# HIGHWAY OR 99W SOUTH CORVALLIS ROAD SAFETY AUDIT

Corvallis, Oregon

February 2021

### **Road Safety Audit**

**Figure 16: Future Potential Cross-Section**

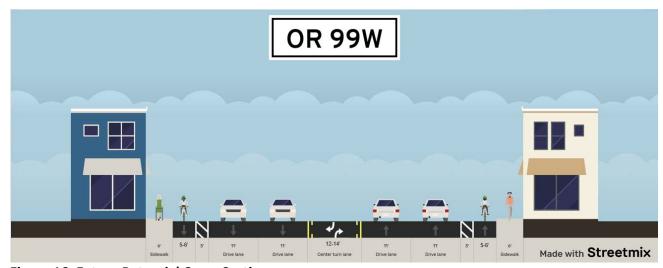
A modified layout of the roadway would create more of a boulevard feeling and would increase the comfort and have a positive influence on the safety of the people using the corridor. This implementation can occur primarily through restriping. Narrower lanes would encourage slower and more careful driving behavior. An additional buffer for the bicycle lanes, preferably with vertical elements such as flexposts, would create a safer and more comfortable environment for bicyclists. Additional medians (with landscaping) where feasible would also encourage more careful driving.

Figure 16 below presents a potential typical future cross-section of OR 99W. The presented cross-section is just one of the possible options and the lane widths can be finalized once the exact roadway measurement is available.

Figure 18: Potential Crossing Improvement at SW Tunison Ave/SE Viewmont Ave

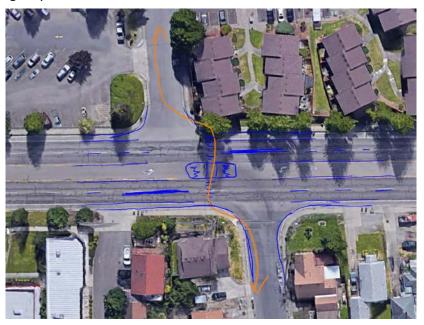
In addition to the corridor-wide crossing enhancements, the RSA team believes that a few location-specific improvements will bring a great safety benefit. As mentioned above, a marked pedestrian crossing is desired at offset SE Viewmont Avenue/SW Tunison Avenue.

Figure 18Error! Reference source not found. below presents a crossing layout that is proposed by the RSA team. It includes marked crosswalk striping and a median. A pedestrian hybrid beacon (PHB) should be considered at this midblock location, especially because of the proximity to the school. Pedestrian Hybrid Beacon is a traffic control device that remains dark for drivers until activated by a pedestrian. Once activated, it begins to flash yellow to warm motorists, which is then followed by a steady yellow and a steady red phases<sup>4</sup>. (see Figure 19Error! Reference source not found.) This would replace the RRFB that currently exists between SW Tunison Avenue and SE Richland Avenue (approximately 230 feet to the south). If a PHB is not feasible, an overhead RRFB should be considered. Unlike an PHB, an RRFB does

Notably, a median at this location is likely to interfere with the emergency vehicles entering and exiting the fire station on SW Tunison Avenue. The fire station is likely to be relocated in the next five years. If a PHB or overhead RRFB is installed before the relocation of the fire station, the RSA team suggests working with the fire department when designing the crossing to come up with a feasible design that does not interfere with emergency vehicle access.

Figure 25: Proposed Striped Bicycle Boxes at Alexander Avenue

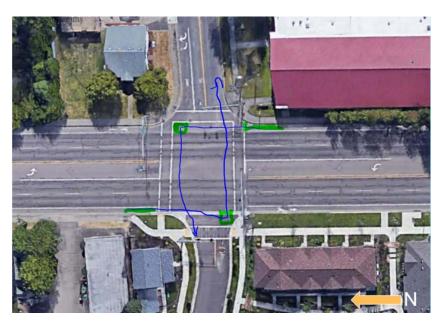
Moreover, the RSA team proposed adding bicycle two-stage left-turn boxes at SE Alexander Avenue. Two-stage left turn boxes provide a marked place for bicyclists to wait for making a two stage left turn at an intersection. Figure 24 and Figure 25 present an initial concept of the proposed improvements at these two intersections.

**Figure 28: Roundabout Solution**Source: Base Image from Google Earth

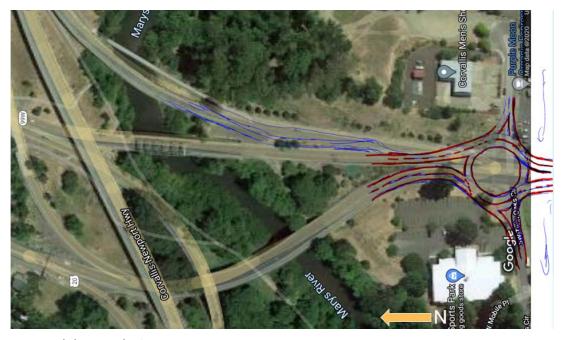
This solution uses a roundabout to manage the speeds of traffic entering South Corvallis and those travelling onto the OR 34 east ramp. Figure 28 presents a concept sketch of a roundabout layout. This solution may require purchasing some right-of-way but is not expected to impact any existing buildings. In addition to managing speeds, the roundabout would provide an opportunity for people driving to make a U-turn on the corridor, increasing the ability to add medians for traffic calming and reducing conflict points along the corridor without reducing access to driveways.

Adding a roundabout could also allow for wayfinding signs to indicate entry to South Corvallis. This could serve as a "Gateway" to the area and provide traffic calming, reducing the ability to speed through the area.
